MOUNT EVERETT ACADEMY  
STABILIZATION AND ADA IMPROVEMENTS

**ADDENDUM TWO**

December 1, 2021

**MOUNT EVERETT ACADEMY/EGREMONT FREE LIBRARY  
SOUTH EGREMONT, MASSACHUSETTS**

Figure 1: Attic Photo showing brace to be repaired.

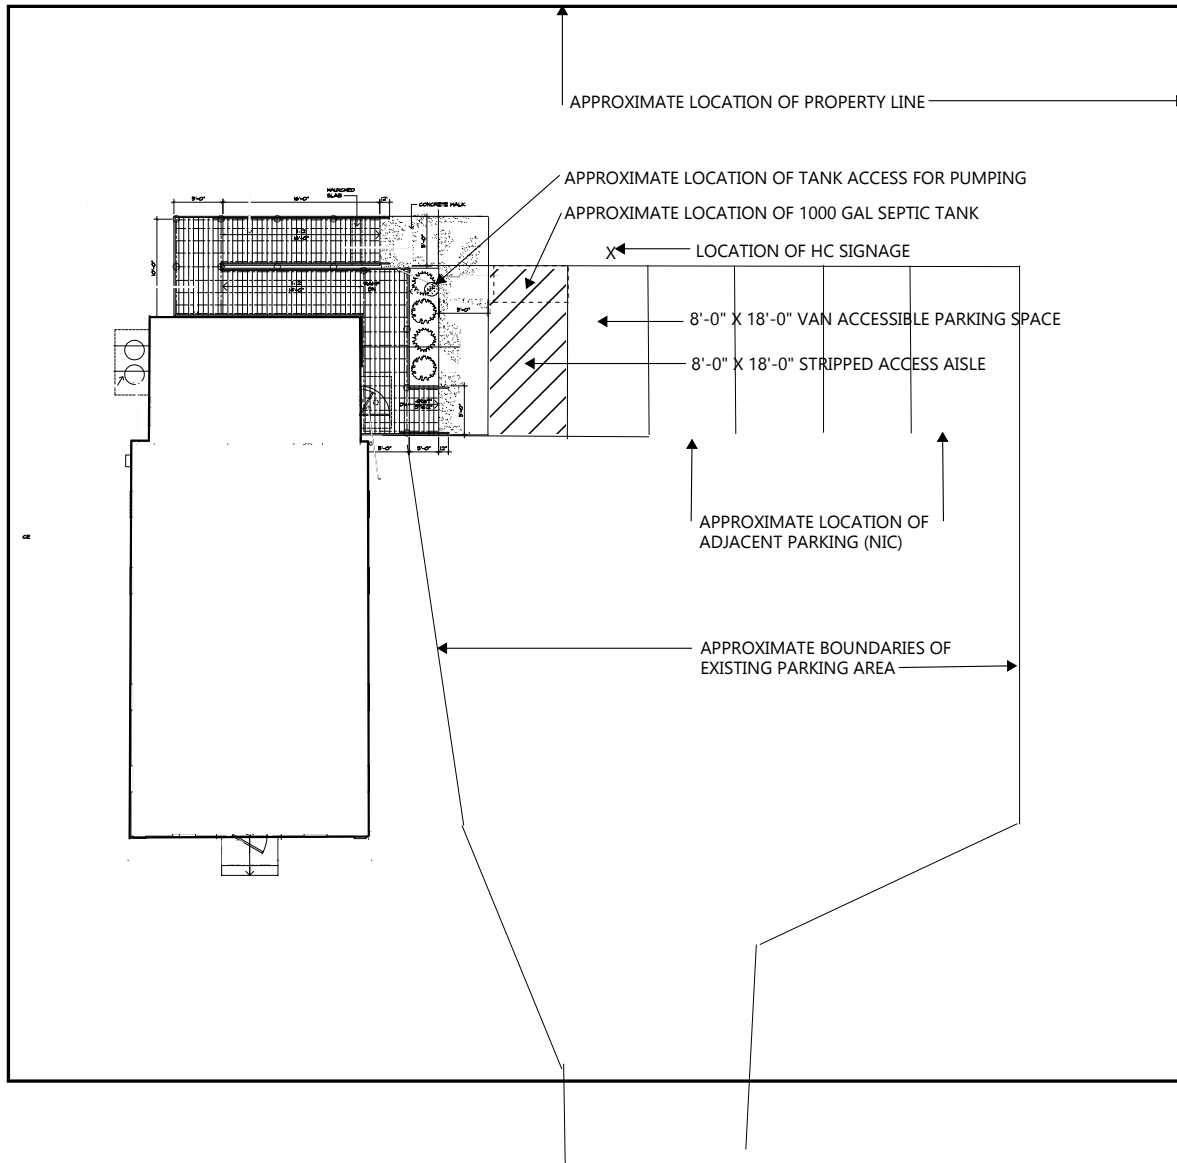
- E. Robe Hook: On toilet room door interior  
Description: Double-prong unit.  
Material and Finish: Stainless steel, No. 4 finish (satin).
8. **Question:** Is there a detail on how to repair the attic truss members?

**Response:** The eastern attic truss brace was partially removed and should be replaced with sistered 2 x 8 Douglas fir members, through bolted to the lower partial brace and at the upper vertical member. Consider the length of the missing element to be 12' for the purpose of bidding. See photo below.

## SILL REPLACEMENT DETAIL / JOIST REINFORCEMENT DETAIL

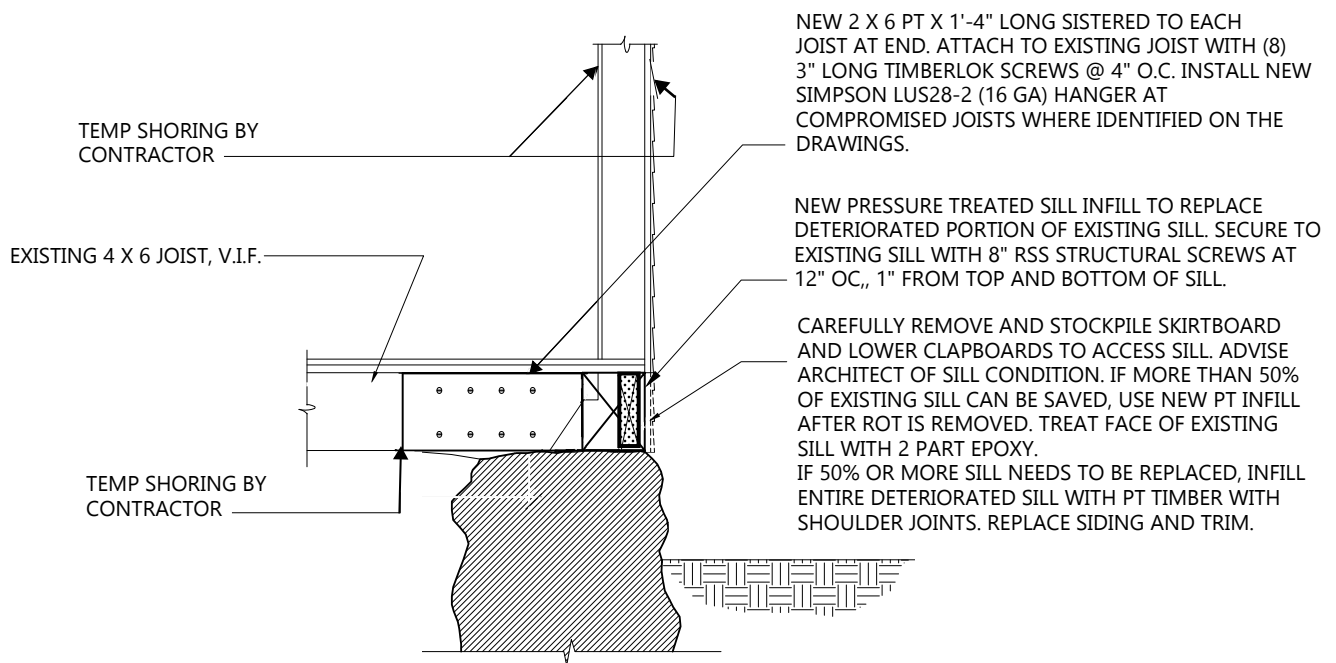
10. **Question:** Please provide a detail of the timber sill replacement per the unit price list.  
**Response:** See Attached SK-2.
11. **Question:** Please provide photographs of underfloor conditions.
